**PROJECT: City of Cottage Grove
Bohemia Park Expansion**

ADDENDUM #4

Branch Engineering Inc. Project No. 22-001K

Sheet No. **C100**

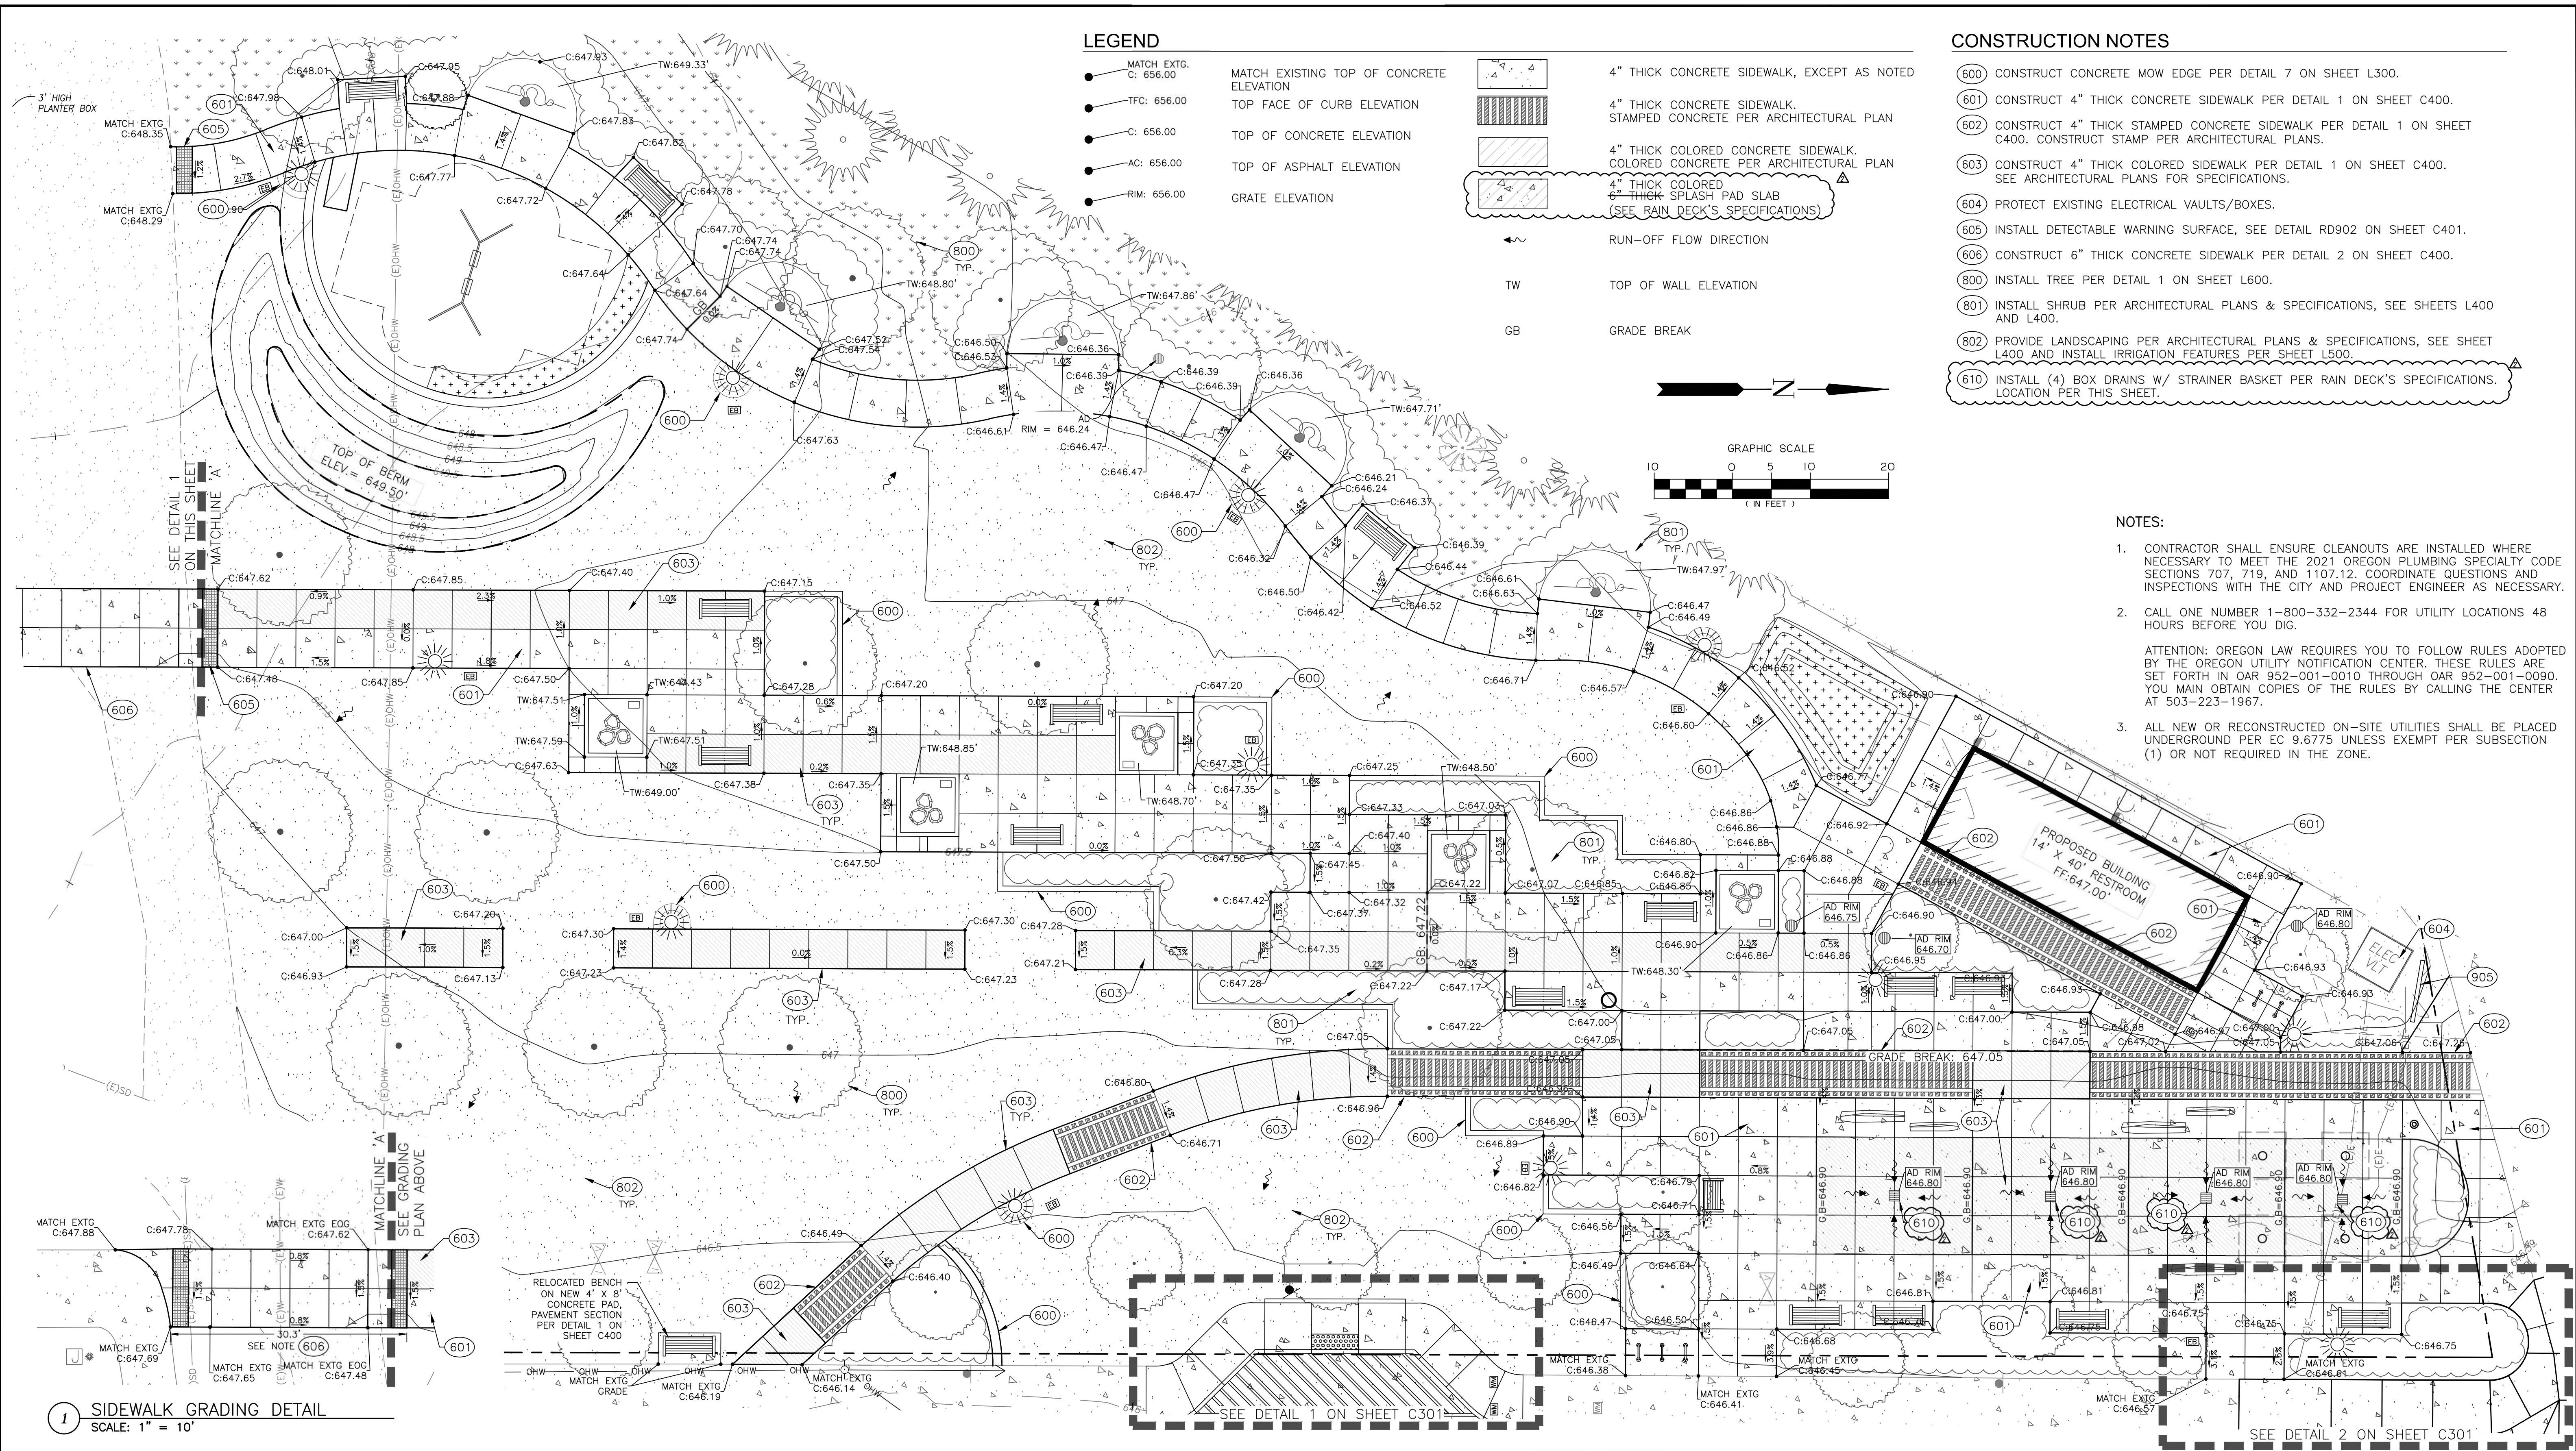
Contractor Question – Bid item 16 Adjust meter and Valve Boxes – I am only seeing one meter to be adjusted on sheet C301 note 150-U. Can you confirm quantities for this item or identify notes for additional adjustments. **Clarification:** There are seven total of water meters and valves that need to be adjusted per Plan sheet C100 Existing Conditions and Demo Plan, see construction notes notes 105 and 114 on this plan sheet and sheet C100 included in this addendum.

No.	DESCRIPTION	DATE
△	REMOVE CONSTRUCTION NOTES 107 AND 132	4/26/24
△	ADD IRRIGATION VALVE W/ BUBBLE NOTE	5/02/24

Sheet No. C400

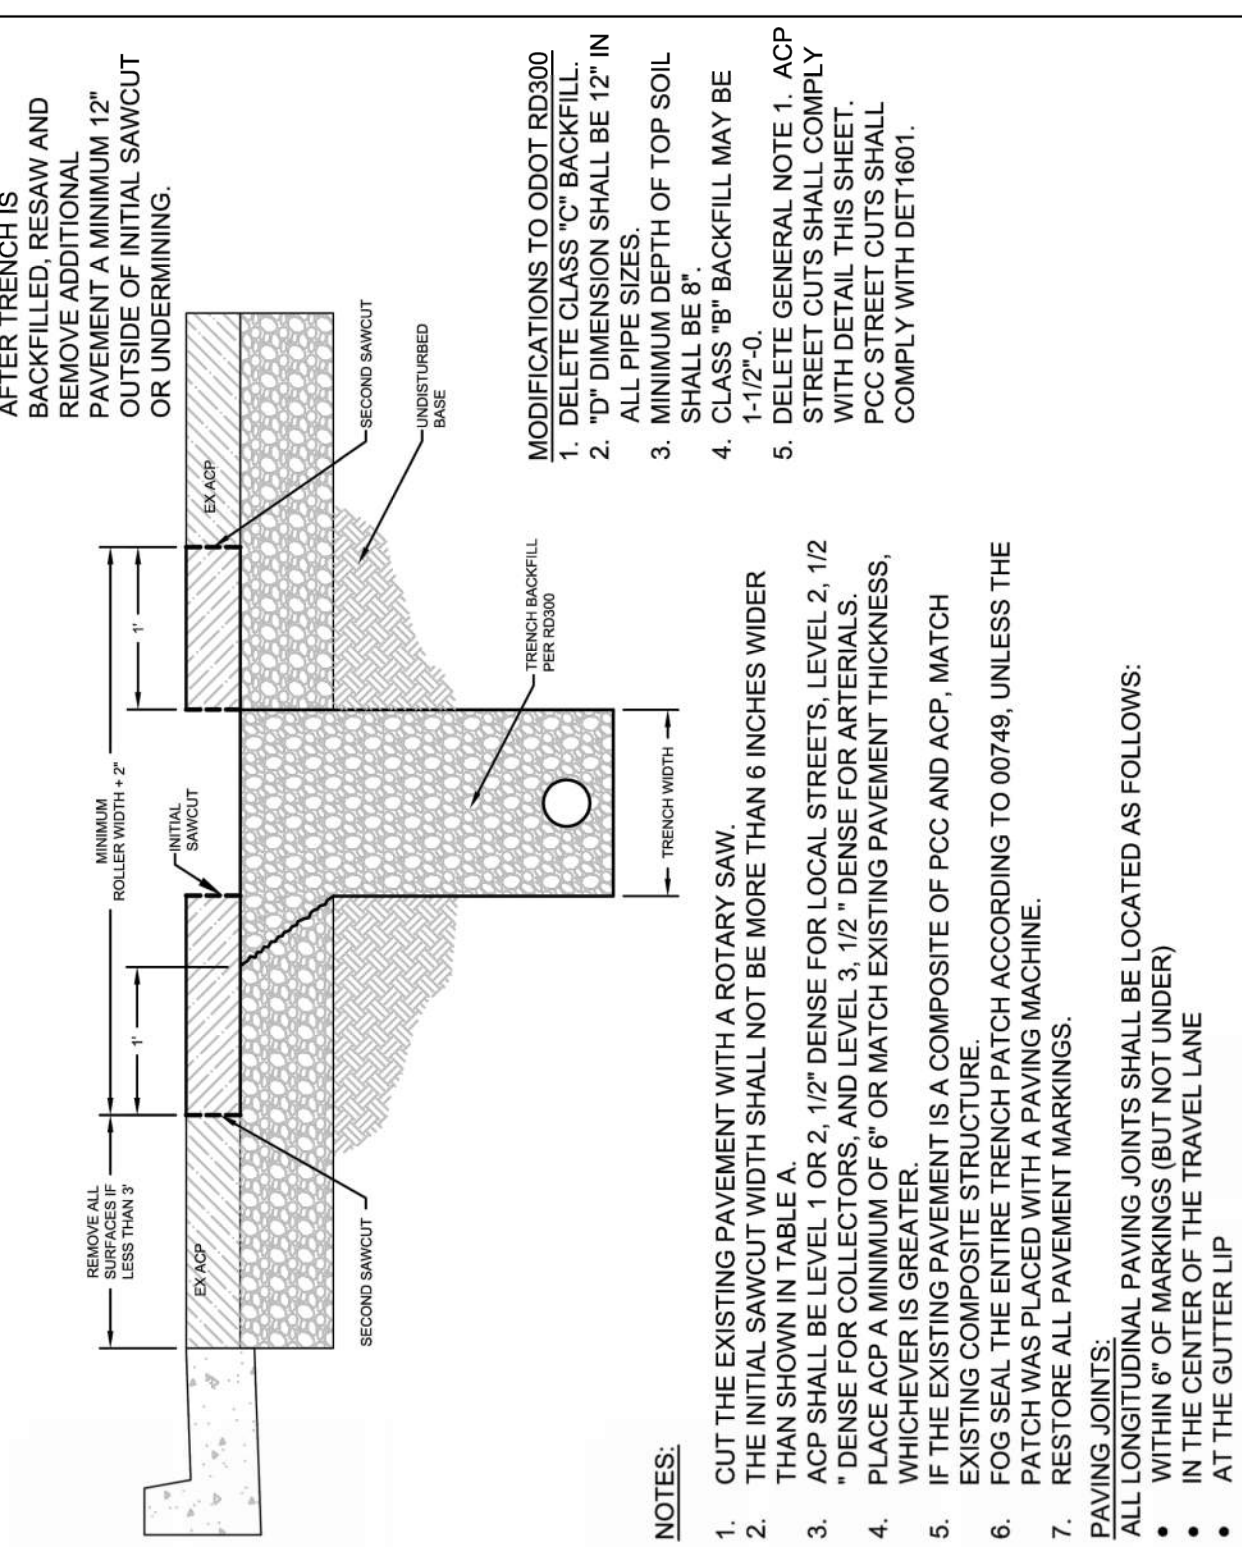
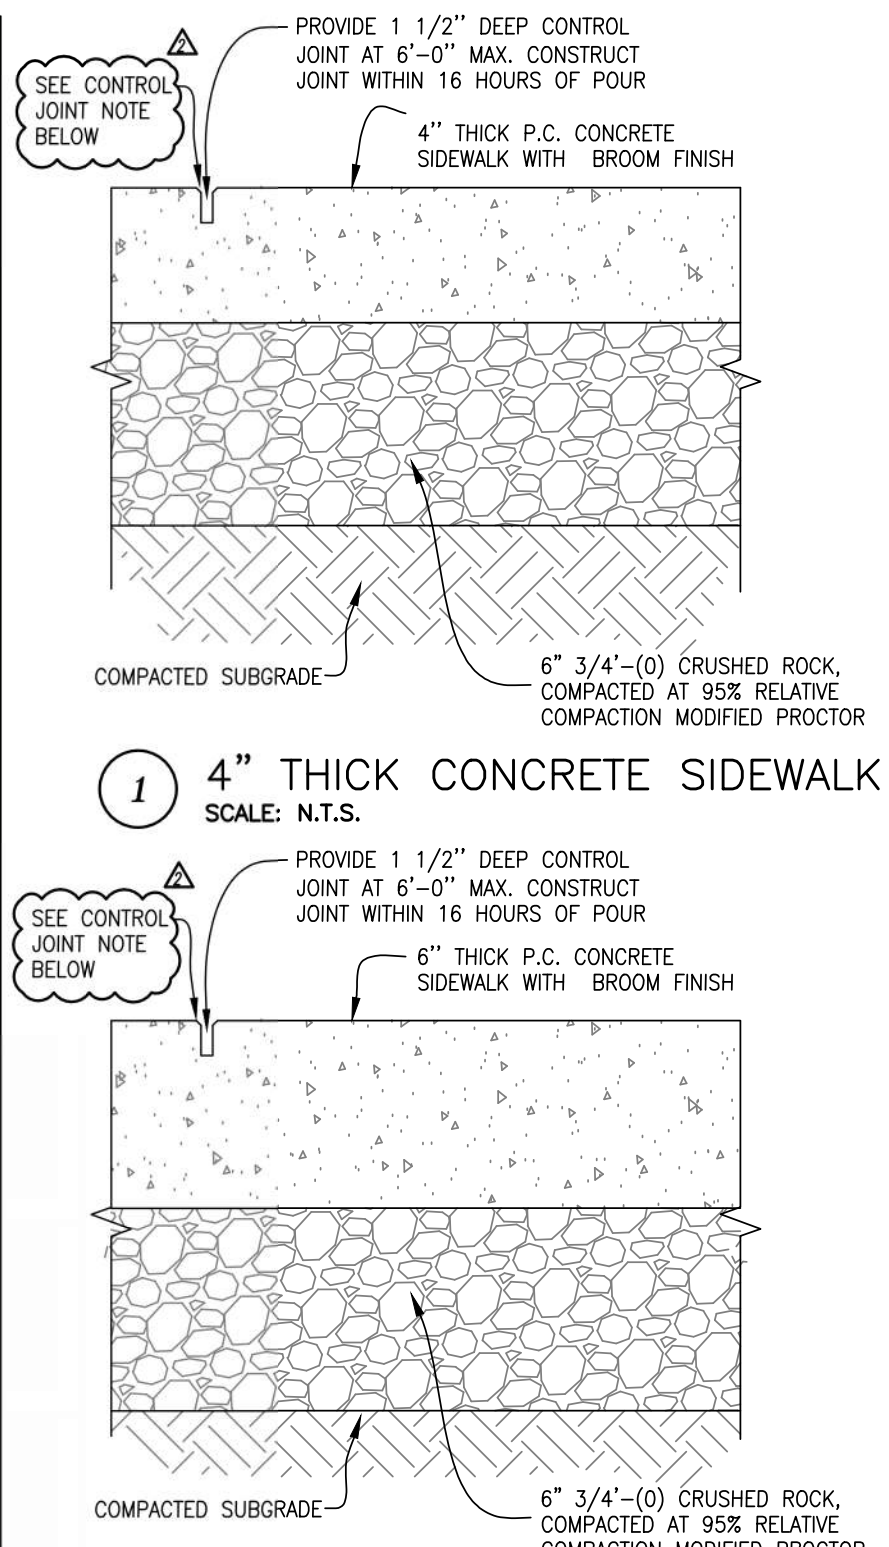
Contractor Question – Details 1 & 2 on C400 show non-reinforced concrete with tooled joints with no sealant for all the site concrete, detail 1 & 2 on S501 show saw cut and sealed joints for the bathroom slab only, is that correct? **Clarification:** Details 1 & 2 on Sheet C400 are general details for site Concrete Paving and Decorative Concrete. There is no joint sealant specified for tooled contraction (a.k.a. control) joints. Concrete Paving and Decorative Concrete joint types shall be per the details listed above and Section 700 - 321313.3.5 & 321316.3.2.D. Please note that contraction joints in Stamped Decorative Concrete are specified to be scored with diamond blade and rinsed clean. Therefore, please **ADD** the following note to Detail 1 & 2 on Sheet C400. "Note: Control joints as specified EXCEPT at Stamped Decorative Concrete. See Specification Section 700 - 321316.3.2.D. See Section 700 - 321313.3.5 for additional information regarding other joint types." Structural sheets beginning with the letter designation "S" are considered Structural Sheets and are specific to building structures. The concrete for structures shall be per Section 700 - 033000 Cast-in-Place Concrete. The details shown on Sheet S501 do not apply to Concrete Paving or Decorative Concrete.

CONTROL JOINT NOTE: CONTROL JOINT AS SPECIFIED EXCEPT AT STAMPED DECORATIVE CONCRETE. SEE SPECIFICATION SECTION 700 - 321316.3.2.D. SEE SECTION 700 - 321313.3.5 FOR ADDITIONAL INFORMATION REGARDING OTHER JOINT TYPES.

No.	DESCRIPTION	DATE
Δ	CONCRETE CONTROL JOINT NOTE - ADDENDUM #4	5/02/24

1 **PARTIAL SECTION**
ADD4 SCALE: N.T.S.

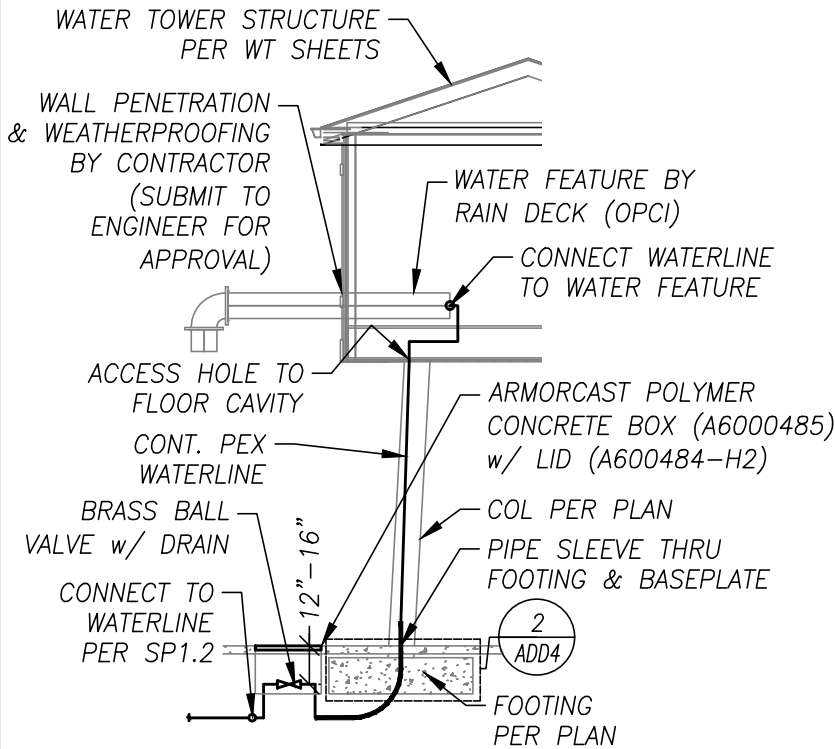
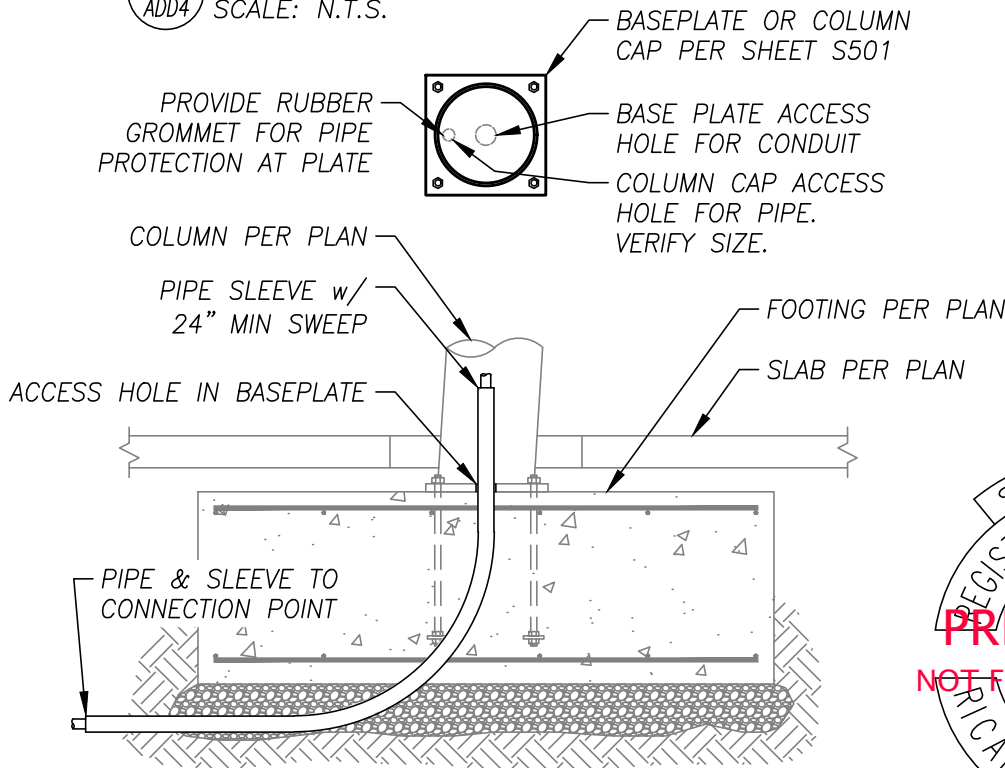
Contractor Question – Is there a water line connection to the water tank? SP1.2 shows a “1” line to rail car filler feature” but no detail for connection to the water tank. **Clarification:** There is a water supply line to the interior space of the water tank. There is also piping and a connection to the water feature supplied by Rain Deck. We have very limited information on the water feature and its connection, but the depiction in the WT plan sheets should be fairly accurate. The connection to the water feature will be a typical plumbing fitting or threaded connection. Additional information is included in this addendum to show how the water line traverses from the ground level to the interior space of the water tower. Please see the ADD4 Drawing included in this addendum for additional information.
